ADDITION TO VERMONT
 STATE HIGHWAY LABORATORY
 MONTPELIER, VERMONT
 GORDON G. WOODS
 ARCHITECT
 ST. JOHNSBURY, VERMONT

STATE HIGHWAY LABORATORY
 REVISED HEATING & AIR COND.
 WORK NO. 547
 DRAWN BY JWG
 CHECKED BY JWG
 DATE OCT 61
 JENNISON ENGINEERING INC.
 CONSULTING ENGINEERS
 85 CALVER ST. SUITE 200, BURLINGTON, VT. TEL. 263-2000
 SHEET NO. H-1A
 DATE OCT 25, 61

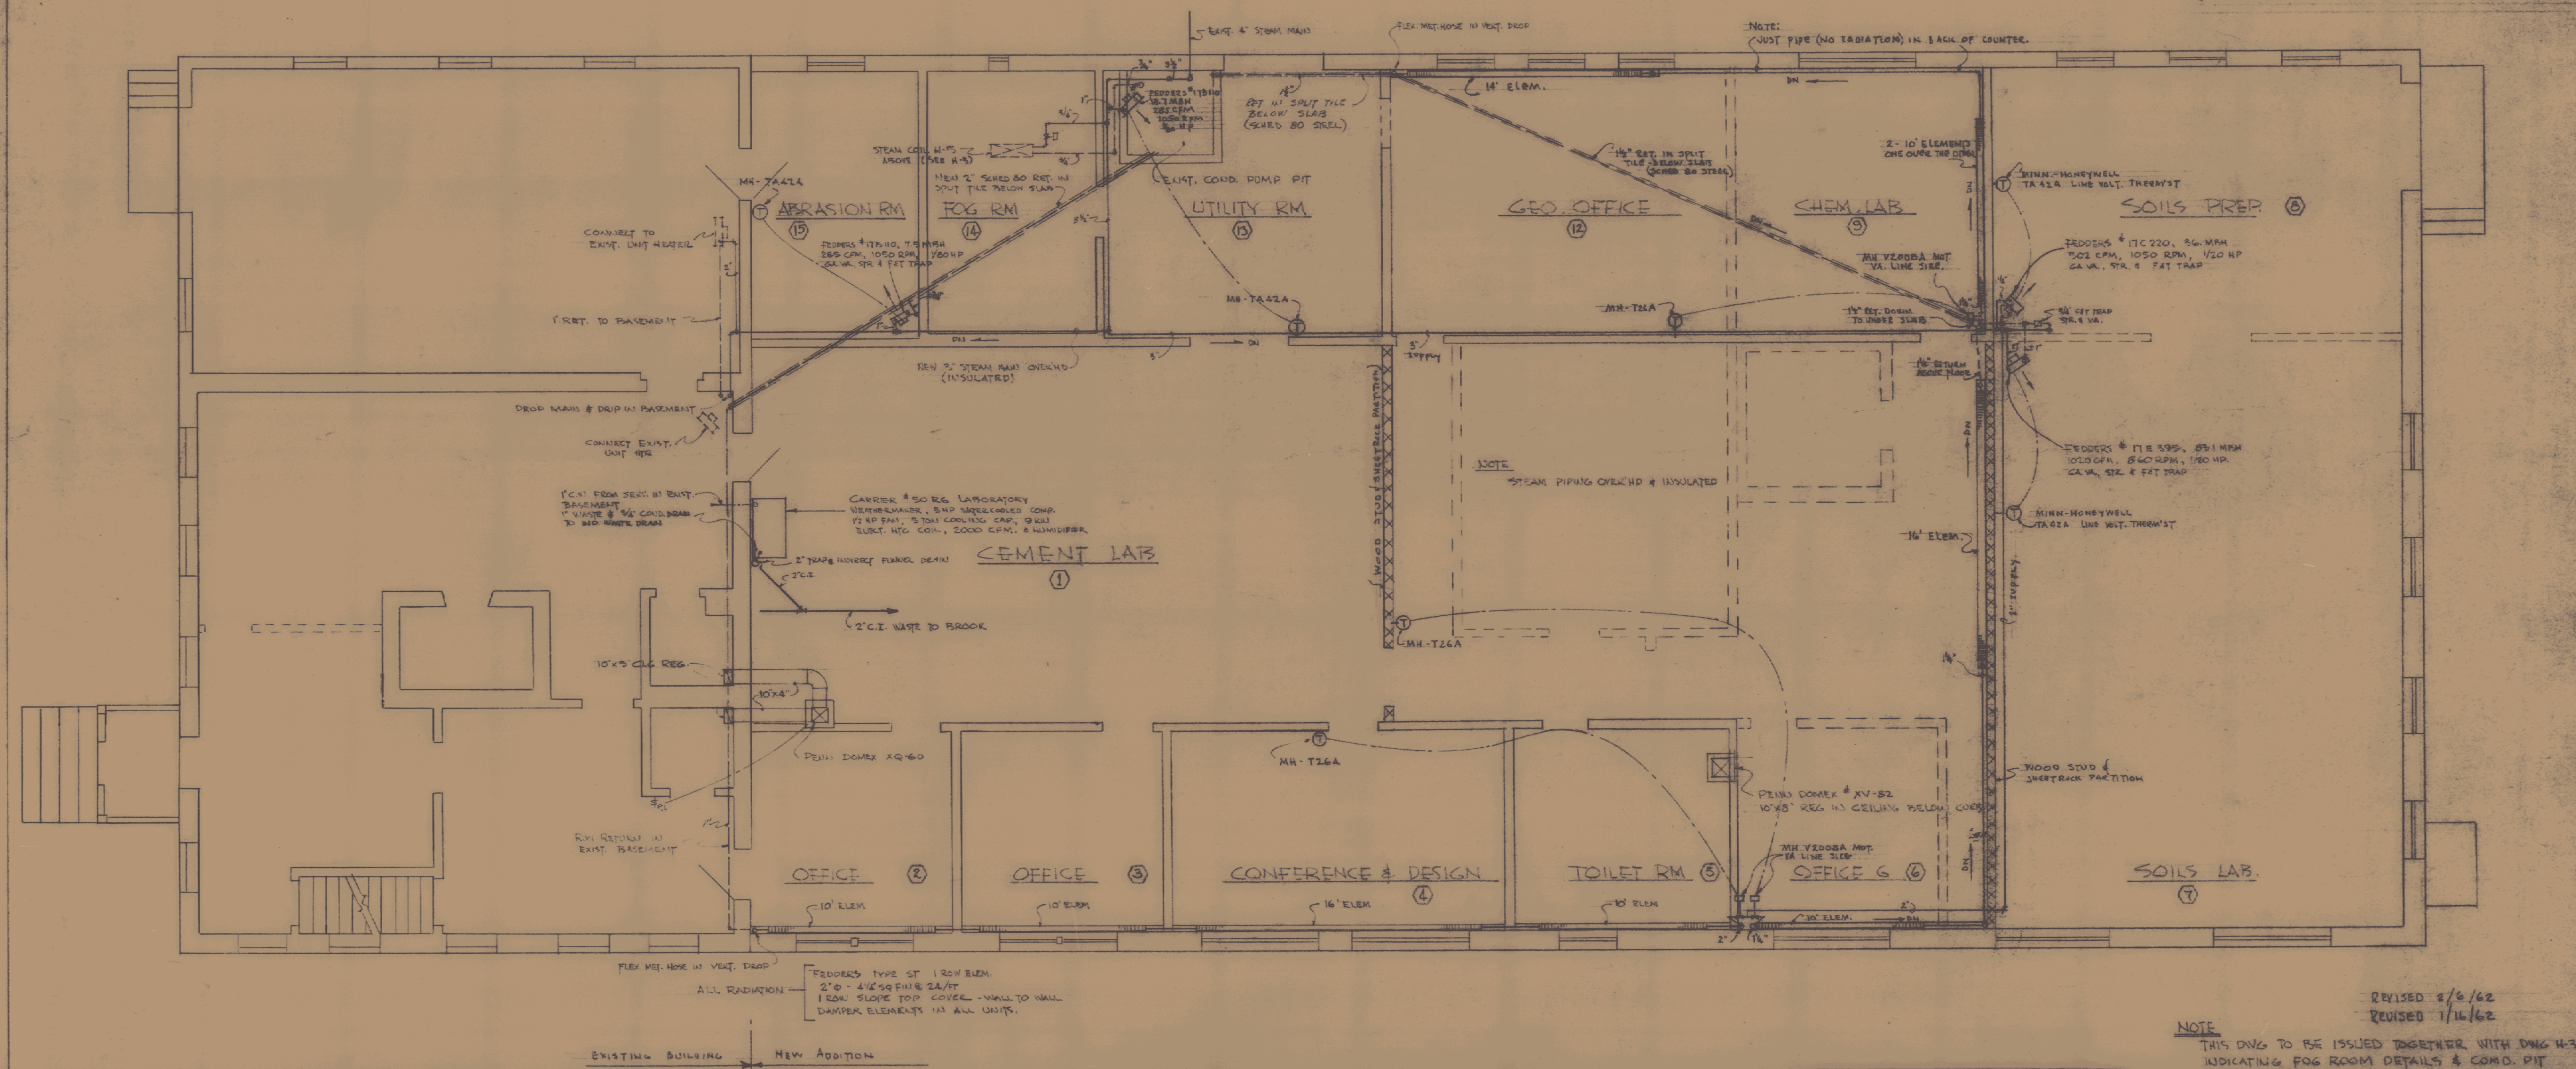
NOTES:
 PLUMBING CONTRACTOR SHALL PROVIDE WATER, WASTE AND CONDENSATE DRAIN FROM NEW A-C UNIT.
 ELECTRICAL CONTRACTOR SHALL PROVIDE POWER CIRCUITS TO ADDITIONAL UNIT HEATERS NOT SHOWN ON ORIGINAL DRAWING H-1, AND ALSO A 50 AMP, 3 PHASE BREAKER IN PANEL DP TO SERVICE THE 3 TON AC UNIT.
 ALL ROOF CURBS AS CALLED FOR ON ORIGINAL PLANS SHALL BE INSTALLED AND CAPPED IN THIS CONTRACT AND WALL OPENINGS PROVIDED & BLOCKED FOR FUTURE H FANS.
 WALL INTAKE LOUVER "P" FOR THE MOIST ROOM SHALL ALSO BE FRAMED IN AND SEALED AT THIS TIME, TO REMOVE THE LOUVER IN THE FUTURE.

REvised 2/6/62
 REvised 7/16/62
 NOTE
 THIS DWG TO BE ISSUED TOGETHER WITH DWG H-3 INDICATING FOG ROOM DETAILS & COMD. PIT DETAILS & ORIGINAL SPECIFICATIONS (omit sections which do not apply)
